SCOTT C. ANDERSON & associates architects

RE: TCL Comments Samana Apartments 6501 Bataan SW

I am writing in response to the review comments dated March 3, 2025

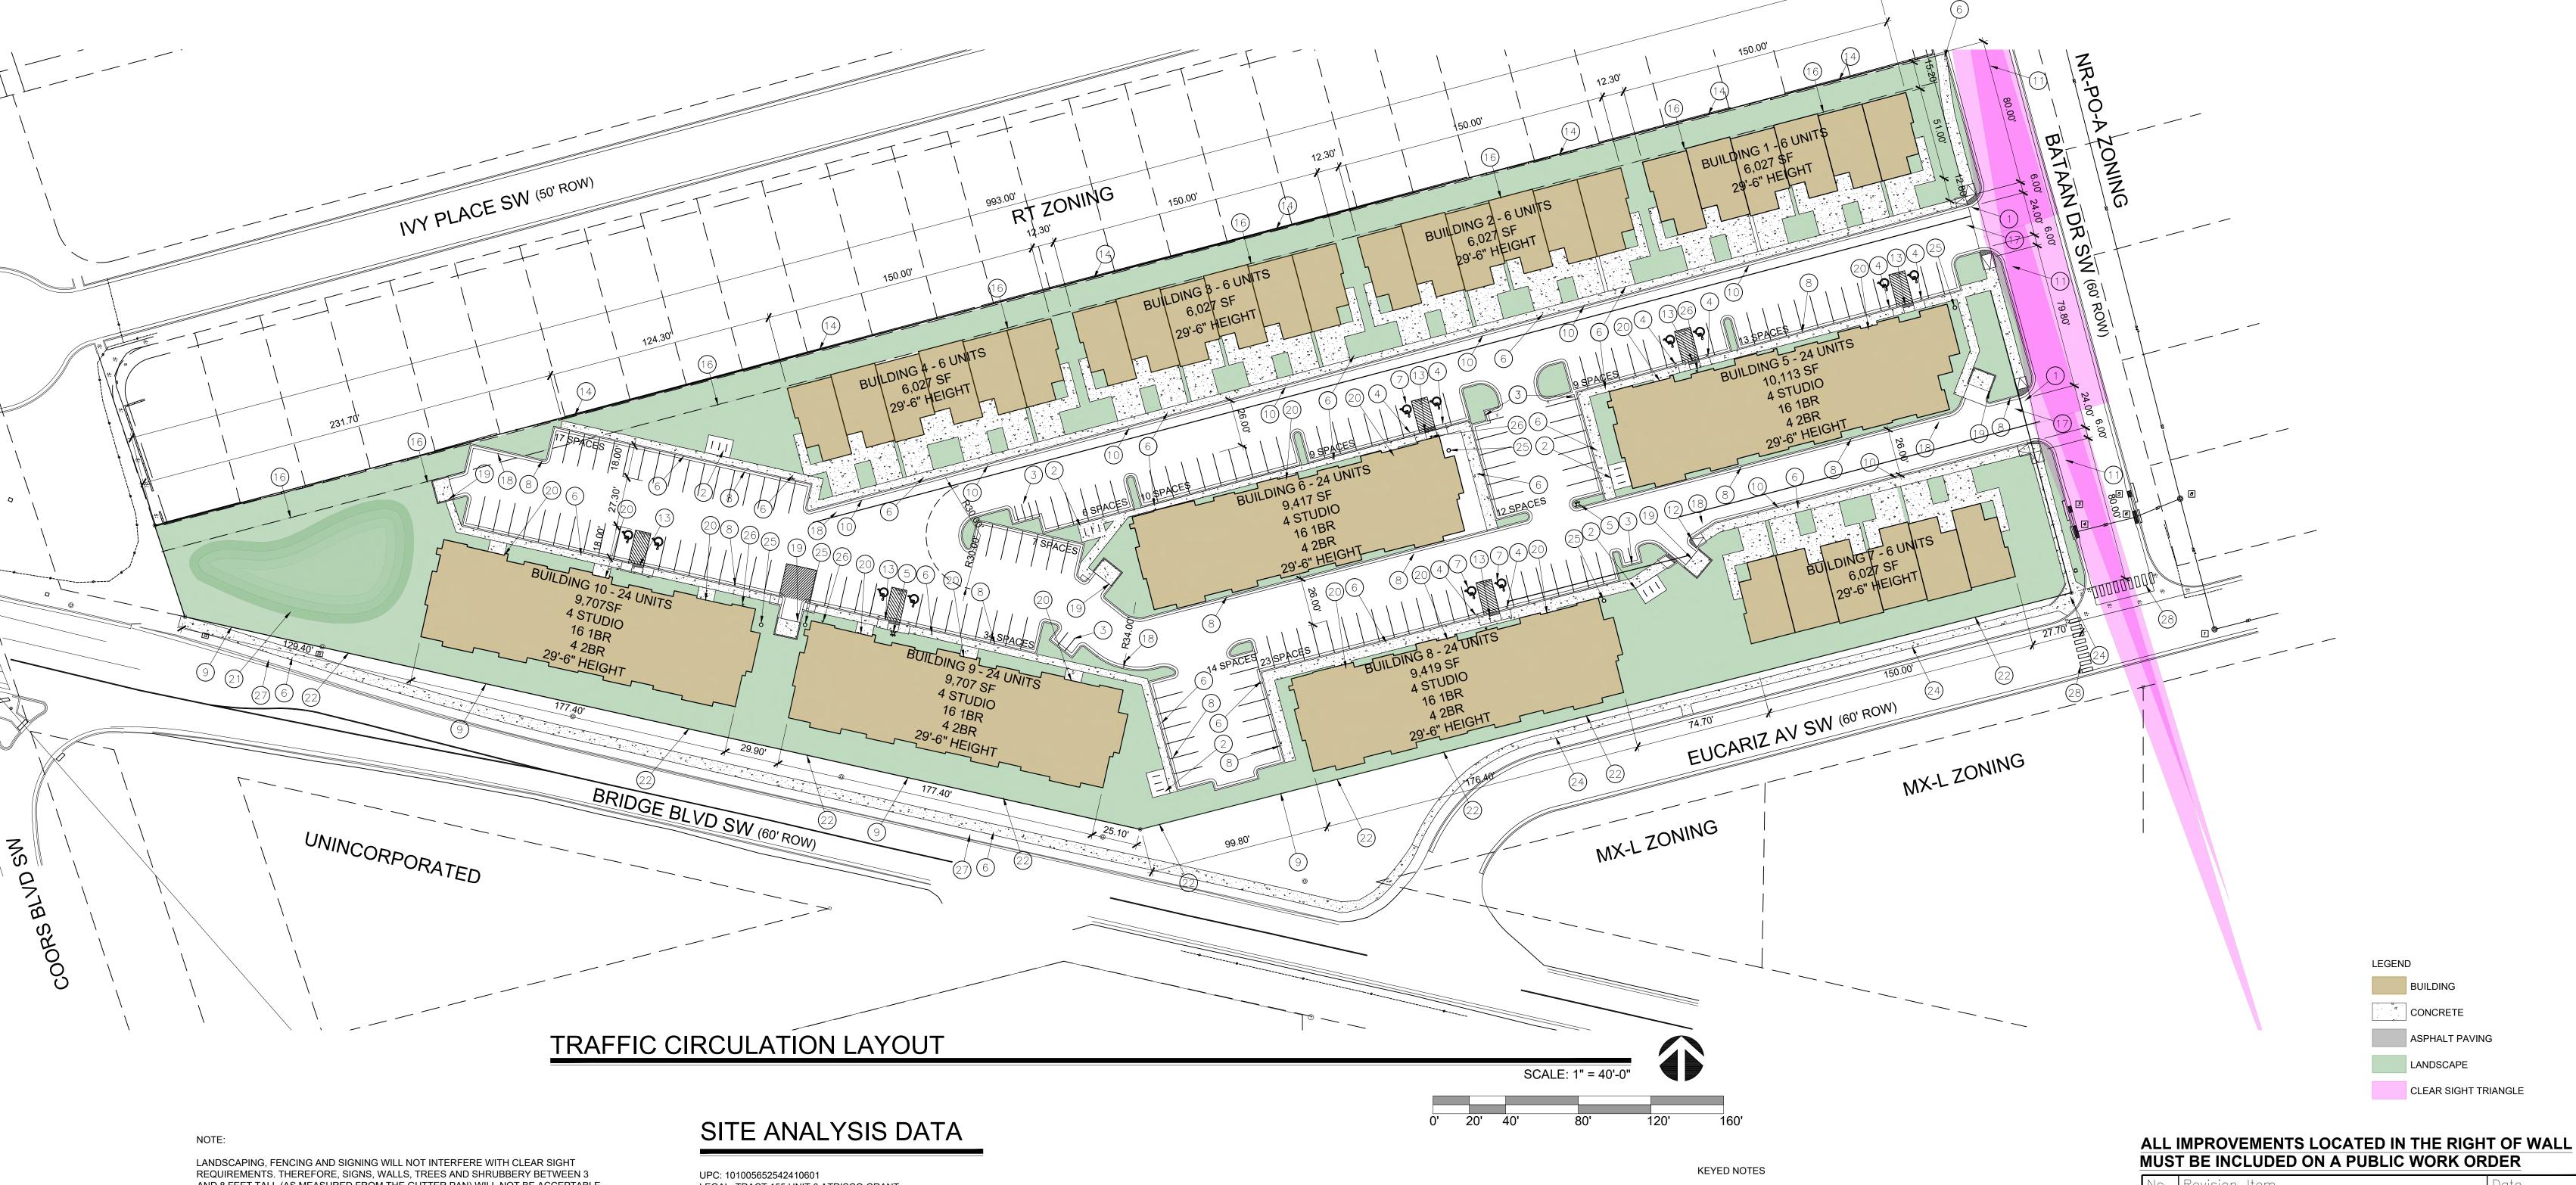
- 1) The PDF dots were removed.
- 2) Airport Dr. ROW added, there are no sidewalks on Airport, they are on Coors Blvd. The Survey is attached for your reference. The widths of sidewalks for all other streets added.
- 3) The street name was corrected.
- 4) Sidewalk and buffer dimensions added.
- 5) Crosswalks added.
- 6) Details moved to separate sheet.
- 7) Detail references corrected.
- 8) Sheet name changed
- 9) Noted.
